Product Change Notification (PCN)

PCN Number	506825	Date Issued	March 14, 2019
Reason for Change	Change to Product		
Change Type Description	This letter is to inform you that changes are being made to the part(s) identified in this Notice. The change may affect the fit, form, function or appearance of the parts, or it may result in a change to the specification. The pictures below show an example of the possible differences.		
Reason for Short Notice	Corrective Actions		
Assessment of Change	Test report/Specification Test Report		
Internal Molex Qualification Date	March 15, 2019		
Sample Availability Date (Changed Part)	March 15, 2019		
Planned Implementation Date	March 29, 2019		
Method of Identifying Change	Factory order number

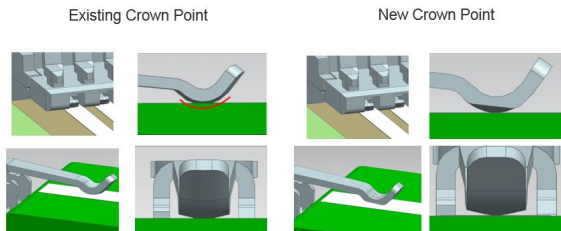
- Molex is making changes to the terminal crown point on RAST 2.5.
- We will reduce the number of crown point options within this product family to have a single crown point as the preferable terminal.
- This change will increase the connector life span due to an improved contact profile. The new contact profile will experience less plating wear during mating, which will result in improved performance characteristics.
- Part number Impact
 - See attached impacted parts list
- Qualification Reports and samples available upon request after the date shown in the PCN letter
